Model: Model AR-P2	Date: 26-Jan-06	No.: RG139001a
--------------------	-----------------	----------------

Subject: Engine firmware release note for AR-P2		Prepared by: K. Moriizumi	
From: 1st Tech. Support Sec. Service Support Dept.			
Classification:	<input type="checkbox"/> Troubleshooting	<input type="checkbox"/> Part information	<input type="checkbox"/> Action required
	<input type="checkbox"/> Mechanical	<input type="checkbox"/> Electrical	<input type="checkbox"/> Service manual revision
	<input type="checkbox"/> Paper path	<input type="checkbox"/> Transmit/receive	<input type="checkbox"/> Retrofit information
	<input checked="" type="checkbox"/> Product Safety	<input type="checkbox"/> Other ()

Model: Model AR-P2		Date: 10-Apr-08	No.: RG139008
Subject: Black toner dropping		Prepared by: K. Moriizumi	
From: 1st Tech. Support Sec. Service Support Dept.			
Classification:	<input checked="" type="checkbox"/> Troubleshooting	<input type="checkbox"/> Part information	<input type="checkbox"/> Action required
	<input type="checkbox"/> Mechanical	<input type="checkbox"/> Electrical	<input type="checkbox"/> Service manual revision
	<input type="checkbox"/> Paper path	<input type="chec

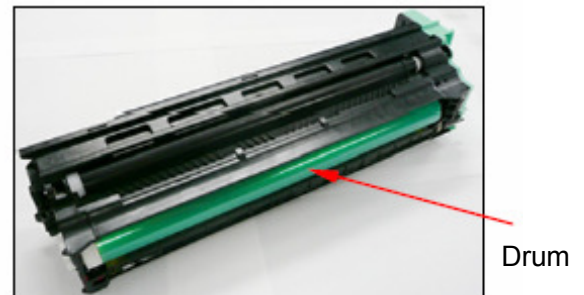
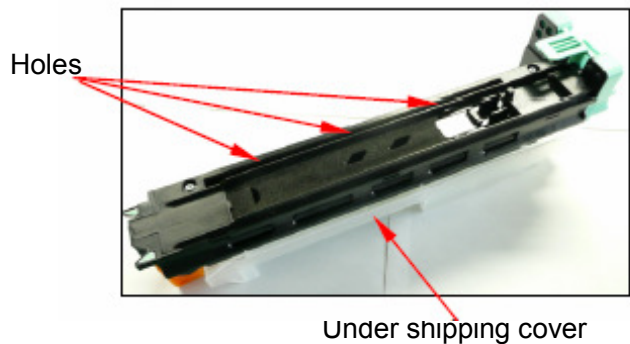
Black spots appear on the printout after the black PCU is replaced.

The toner seals are deformed during the shipping process. The deformed toner seals cannot return to their original shape in low-temperature environments. And as a result, some toner leaks out of the black PCU.

If the symptom is reported, replace the PC shutter seal and PC shutter cover of the black PCU with the following new service parts.

PC Shutter Seal	P/N G1392301	(Model AR- P2)
	P/N G1392303	(Model AR- P1/P1e)
PC Shutter Cover	P/N G1392302	(Model AR- P2)
	P/N G1392304	(Model AR- P1/P1e)

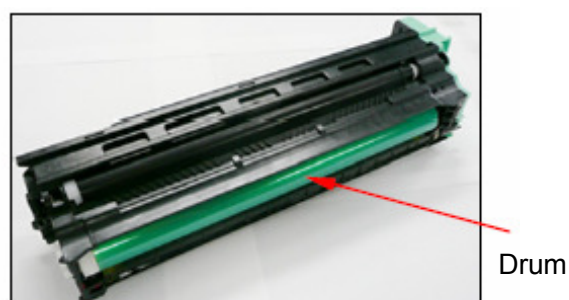
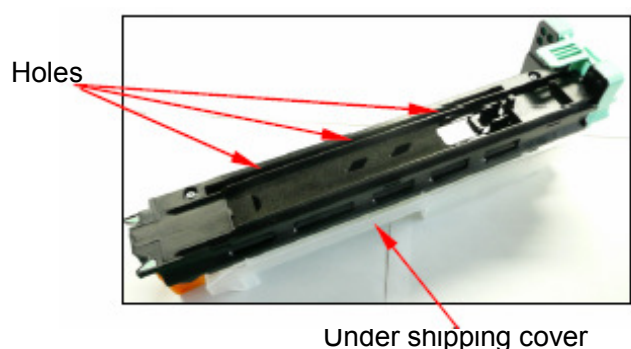
Black spots appear on the printout after the black PCU is replaced.

The toner seals are deformed during the shipping process. The deformed toner seals cannot return to their original shape in low-temperature environments. And as a result, some toner leaks out of the black PCU.

- ***The shape of the shipping cover was also changed. See the cut-in S/N below.***

If the symptom is reported, replace the PC shutter seal and PC shutter cover of the black PCU with the following new service parts.

PC Shutter Seal	P/N G1392301	(Model AR- P2)
	P/N G1392303	(Model AR- P1/P1e)
PC Shutter Cover	P/N G1392302	(Model AR- P2)
	P/N G1392304	(Model AR- P1/P1e)

- Location of toner blasting -

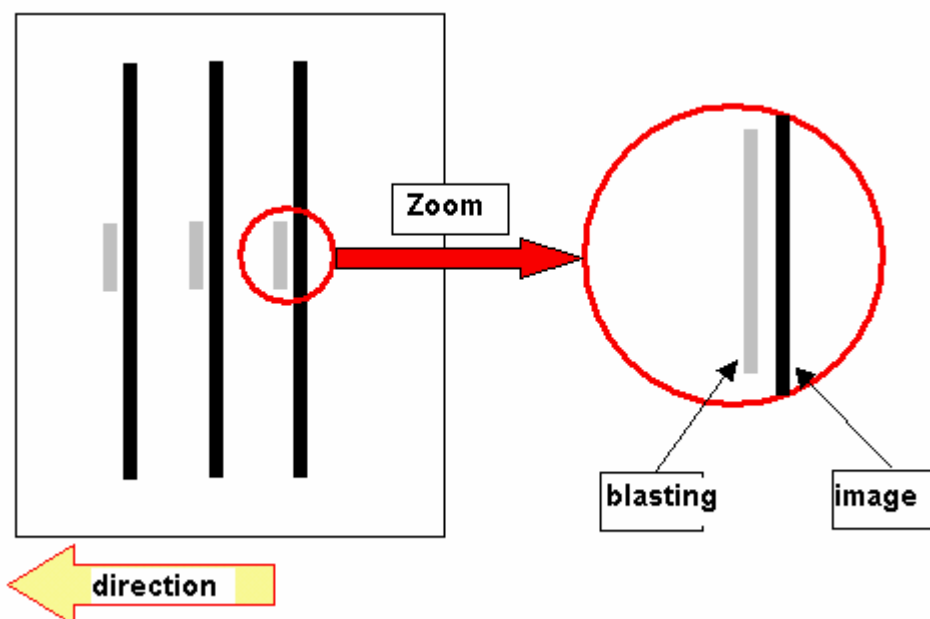
Toner blasting appears just ahead of the image along the paper feed direction.

- Occurs only with black and white printing
- Occurs mainly at the center of the image but sometimes at the side edges.

Related to paper transfer roller bias

1. Change the paper transfer roller bias.
SP 2-403-001 Plain: Bias Sep DC: Plain: 1st
34 -> 50

- Before the position of the guide plate screw is changed -

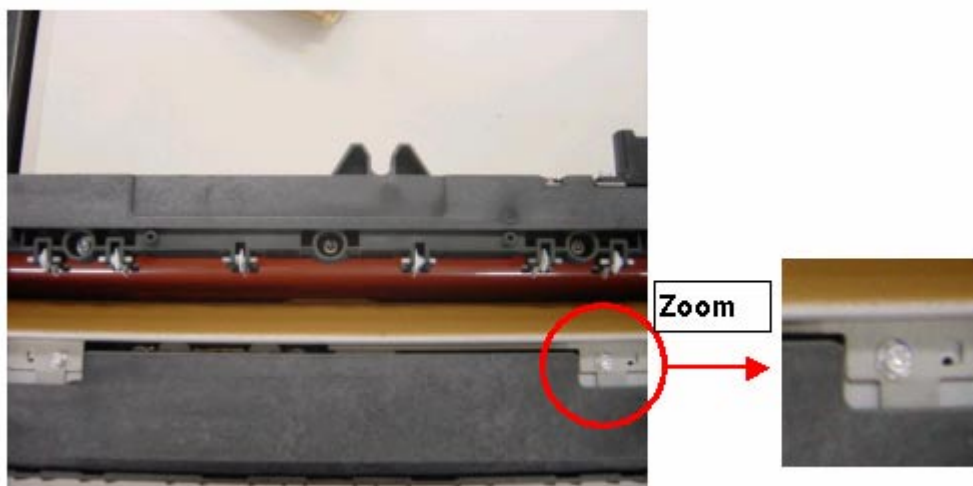
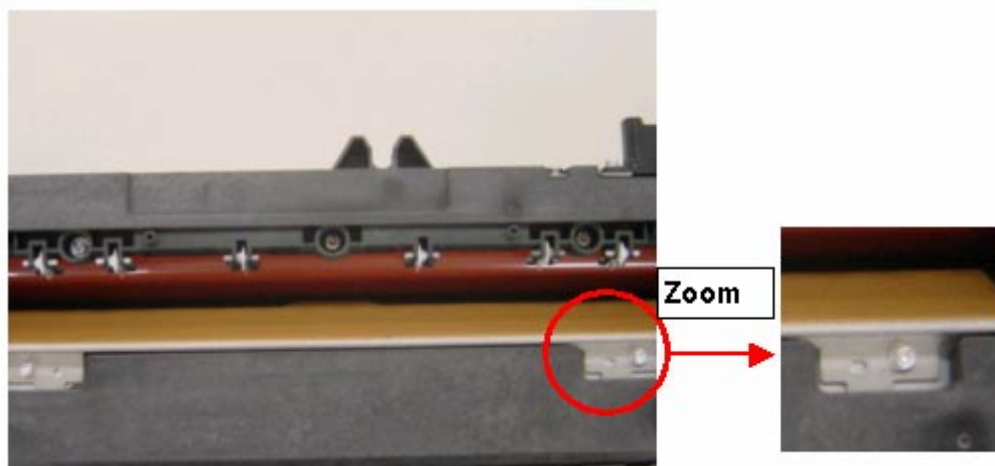
2. Change the position of the fusing guide plate.
- Change the position of the screw shown below, and then move the guide plate toward the pressure roller.

After this screw position is changed, in some cases, mimizu ('earth worms', slight wrinkling) may occur with the first print made of the day.
